U.S. DEPARTMENT OF HOUSING AND URBAN DEVELOPMENT
WASHINGTON, DC 20410-8000

MEMORANDUM FOR: Robert Solomon, Project Manager, National Fire Protection Association

SUBJECT: Manufactured Home Construction & Safety Standards; Proposed Rule (FR-4886-P-01)

Title : Manufactured Home Construction and Safety Standards

Figure 2 A home operating with a system as above will certainly operate in a "negative pressure condition".

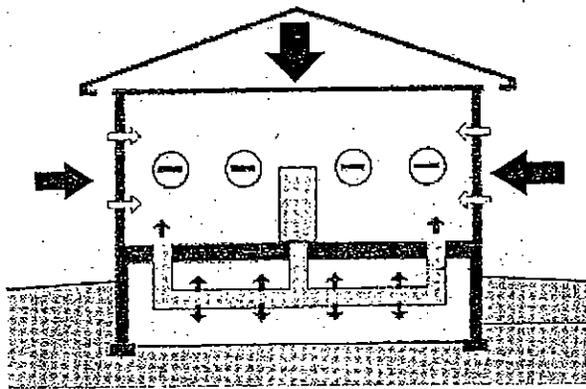
Even minor duct leakage can cause a negative pressure to develop inside the home, which causes humid outdoor air (Hot Humid Climate-Thermal Zone 1) to be pulled through the wall structure at the "path of least resistance". When this humid air makes contact with the cooler indoor surfaces, condensation occurs. If moisture persists for as little as 48 hours, fungal growth then has an opportunity to prosper.

Figure 1 A fresh air vent is designed into the home's a/c system to add fresh air that can be processed before entering the living space of the home. By adding this fresh air at a greater rate than duct leakage, we are able to pressurize the home and push "mother nature" outward.

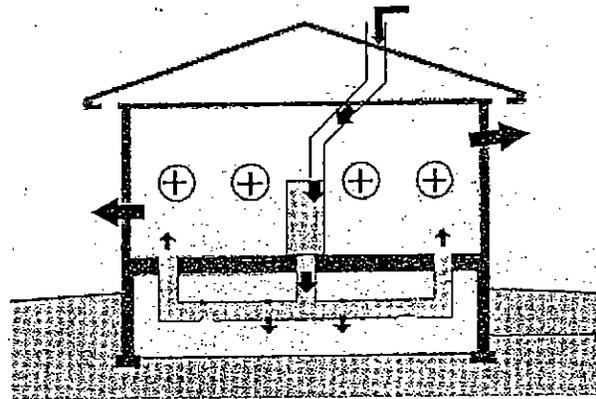
A home that is lacking the proper ventilation system as required by 3280.103(b)(3) as shown in figure 8 and therefore could not be substantiated as required by 3289.103(b)(7).
